We are proposing a change in your area

Reference	TR111-23 Rixon Grove, Mount Victoria – No Stopping At All Times
Location – where we propose to make the change	Outside no.8 Rixon Grove, Mount Victoria
What we'd like to do	• Install No Stopping At All Times roadmarkings outside property no. 8 Rixon Grove.
Why we are proposing the change	• Wellington City Council (WCC) has received a request to remove a car park outside no.8 Rixon Grove. When a vehicle is parked outside this property, vehicle accessibility is restricted and obstructs entry to the driveway of this property. • WCC has received support from the no.8 property owner and eight other property owners. • To improve safety and mitigate the issues highlighted above, WCC is proposing the installation of No Stopping At All Times roadmarkings.
Impact	• Improves safety and accessibility for vehicles • Net parking impact – removal of one unrestricted car park • Pedestrian impact – n/a

Traffic Resolution Plan: TR111-23 Rixon Grove, Mount Victoria – No Stopping At All Times

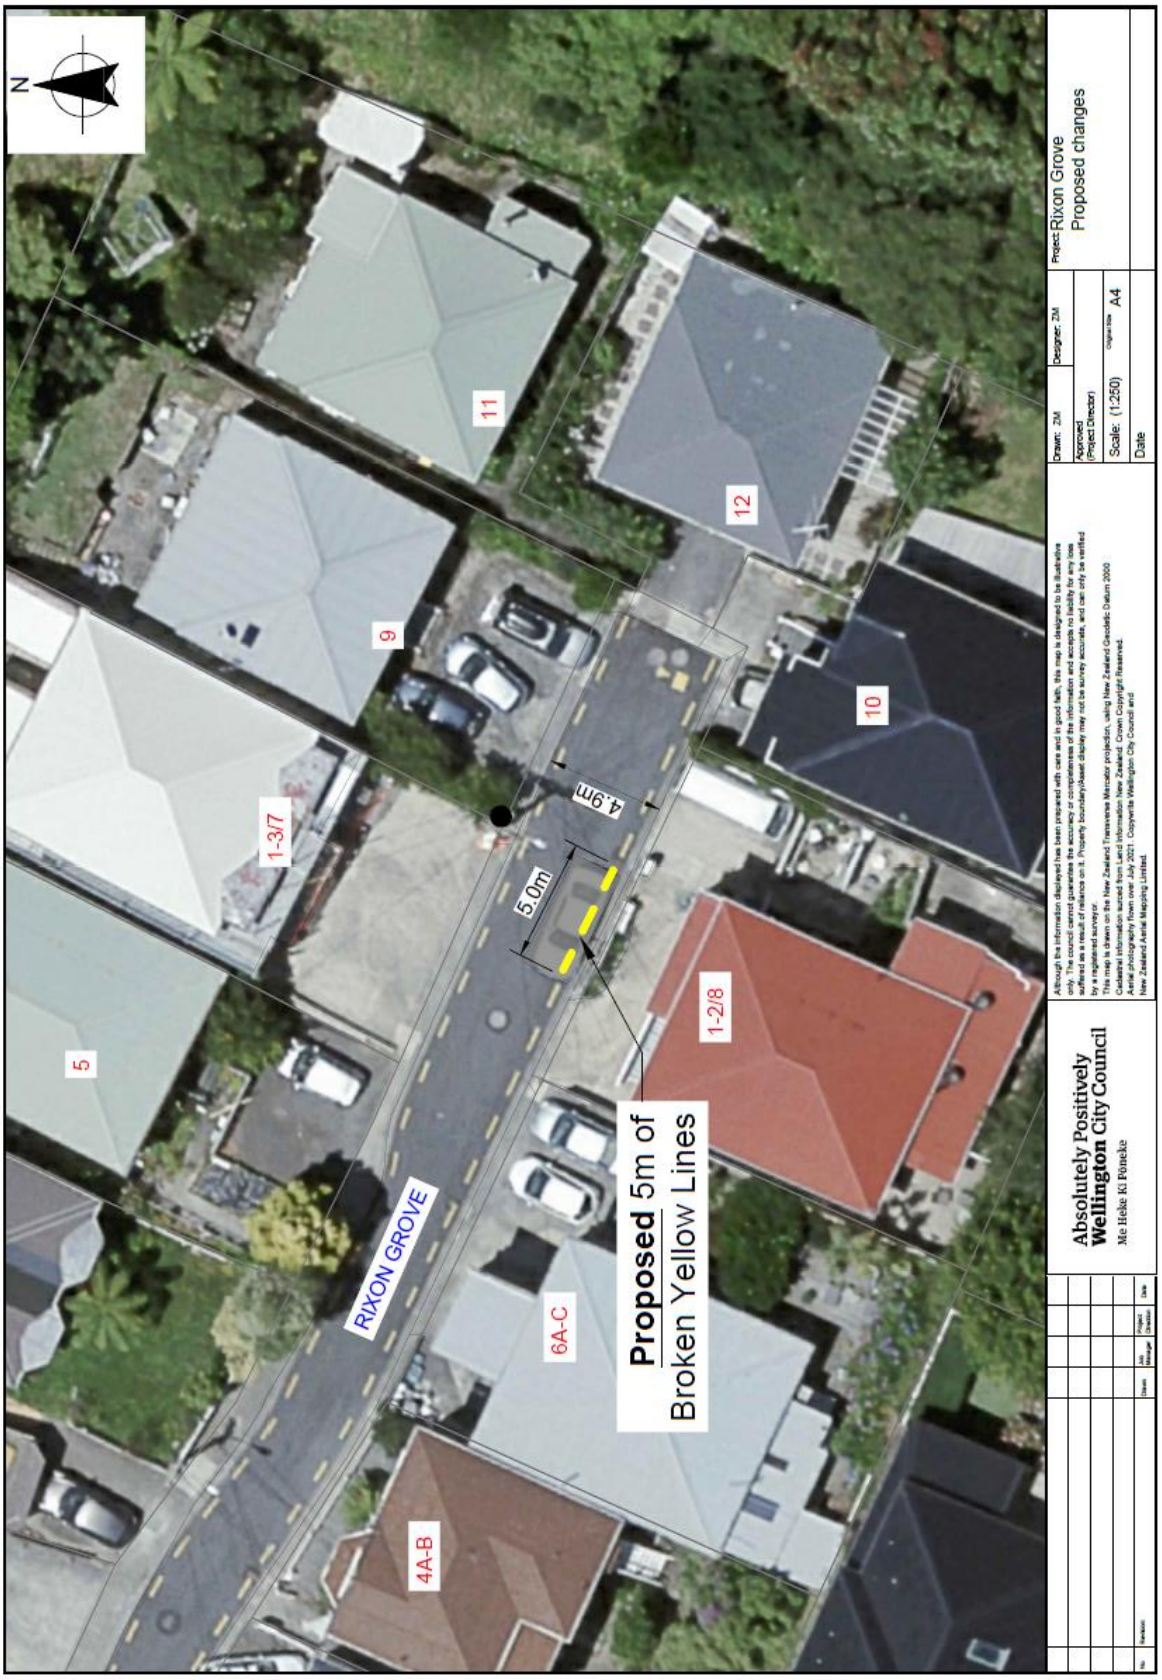
Delete from Schedule D (No Stopping) of the Traffic Resolution Schedule

Column One	Column Two	Column Three
Rixon Grove	*No Stopping, At All Times*	*North side, commencing from its intersection with Austin Street and extending in an easterly direction following the northern kerbline for 100.5 metres.*
Rixon Grove	*No Stopping, At All Times*	*South side, commencing from its intersection with Austin Street (Grid Coordinates X=1749646.3m Y=5426599 m) and extending in an easterly direction following the southern kerbline for 79 metres*

Add to Schedule D (No Stopping) *of the Traffic Resolution Schedule*

Column One	Column Two	Column Three
Rixon Grove	*No Stopping, At All Times.*	*North side, commencing from its intersection with Austin Street (Grid Coordinates X=1,749,647.59 Y=5,426602.18) and extending in an easterly direction following the northern then eastern then southern kerb line for 184.5 metres to its intersection with Austin Street*
